City of Cambridge

RE: File No. 7384 – Senior Center Roof Replacement - Addendum No. 2

SK-2 DETAIL AT FENCE GATE

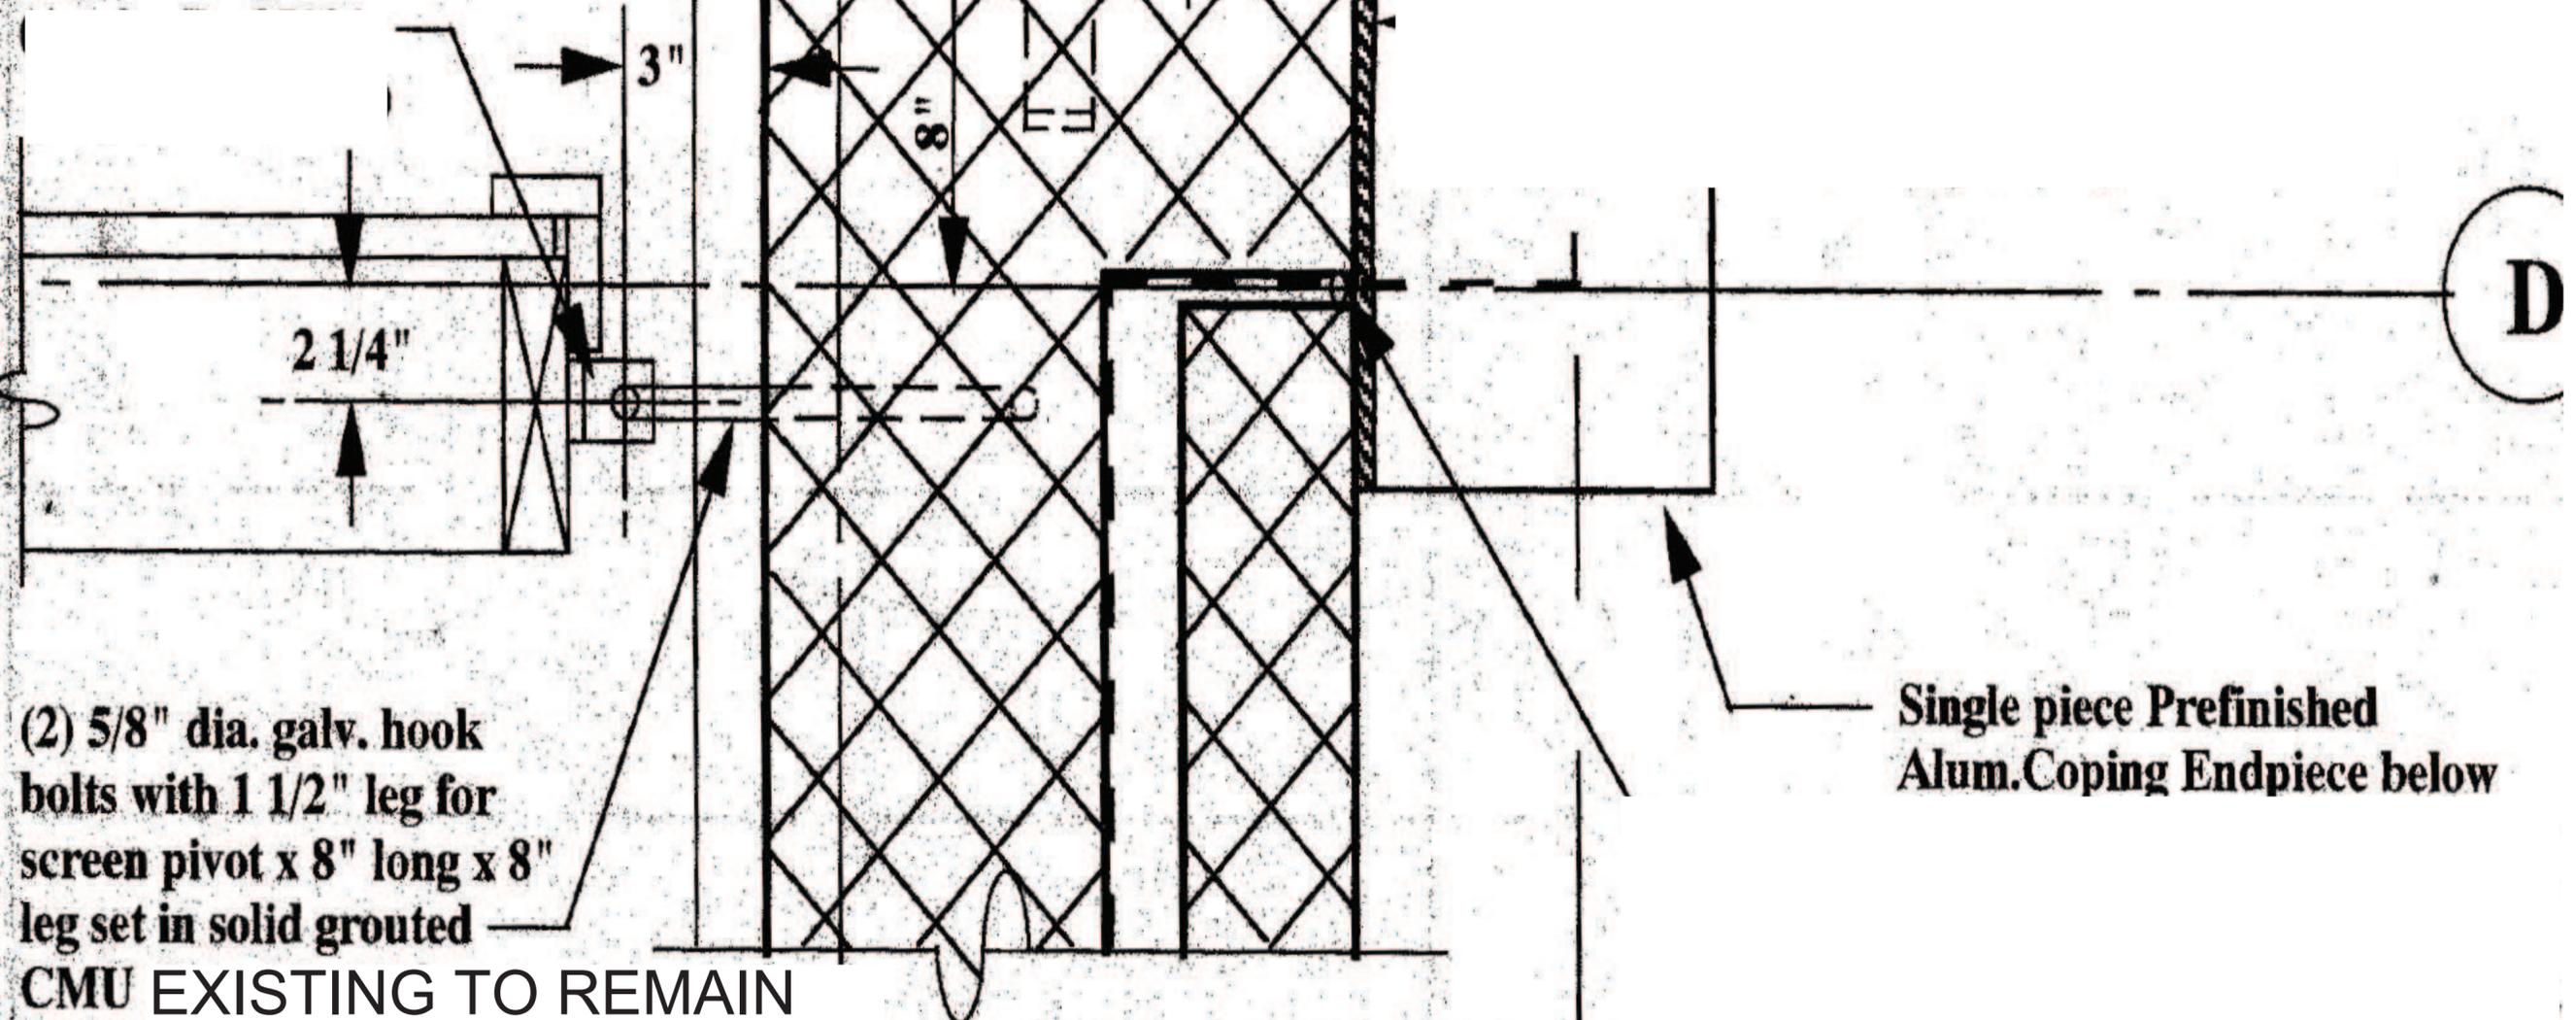
1. **Clarification to 1/A2.02 Lower Roof Demolition Plan, 1/A4.02 Lower Roof Plan and Detail 2/A5.01:** The existing gate shown at the lower roof screen wall is to be removed as part of the screen wall demolition. The new gate is to be constructed to match the existing gate which consists of a 2x6 pressure treated frame that is clad in vertical cedar boards and trim. See attached SK-1 and SK-2 for details of the existing gate construction with clarifying notes.
2. **Clarification to Detail 2/A5.01 and 1/A4.02 Lower Roof Plan:** The Green Screen trellis system does not extend the full length of the screen wall. The trellis system stops at the corner of the jog in the screen wall between column lines 6 and 6.6 as shown on A4.02. However, the prefinished aluminum panel back-up material continues and terminates at the building face as shown on detail 2/A5.01.
